Proposed Revisions to a Standard Plans Index

Originator:	Turley, Joshua	Index Number:	455-124
Date:	8/21/2024	Sheet Number(s):	2
E-mail:	Joshua.Turley@dot.state.fl.us	Index Title:	24" SQUARE CFRP & SS PRESTRESSED CONCRETE PILE

24" SQUARE CFRP & SS PRESTRESSED
CONCRETE PILE

STRAND PATTERN

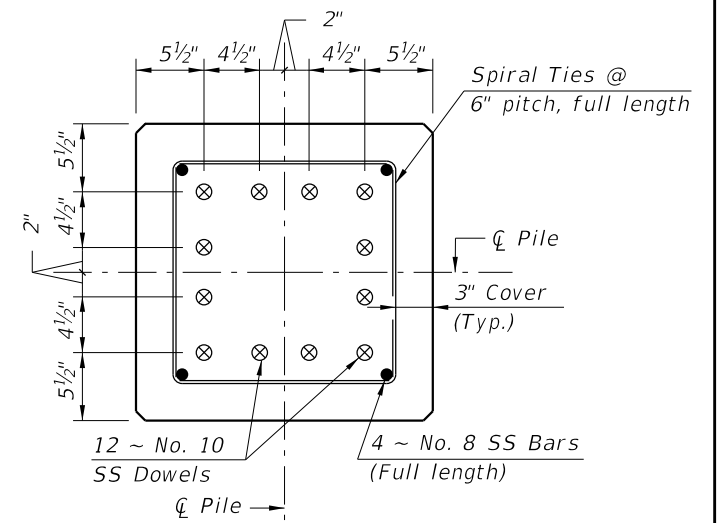
Sheet 2: Adjusted Strand Pattern diameter decimal places

This is a more accurate representation of the nominal diameter driven by the fact that the strands are fabricated in millimeters not inches.

CHANGED TO: 0.520"

CHANGED TO: 0.620"

STRAND PATTERN

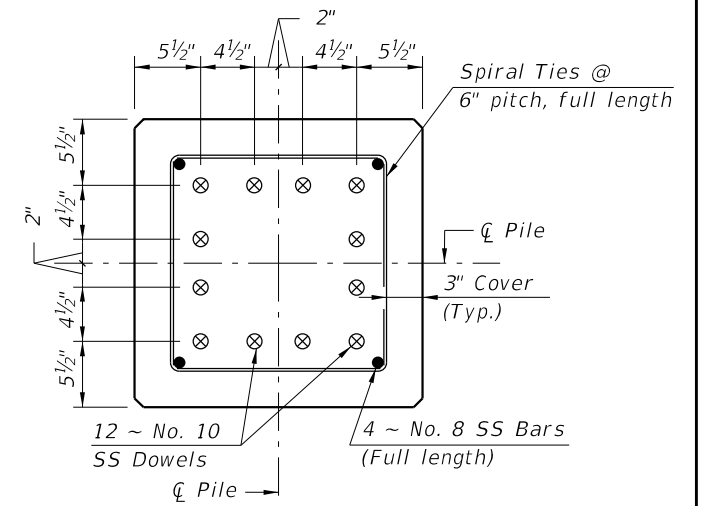
28 ~ 0.52" Ø, HSSS at 26 kips
20 ~ 0.62" Ø, HSSS at 35 kips
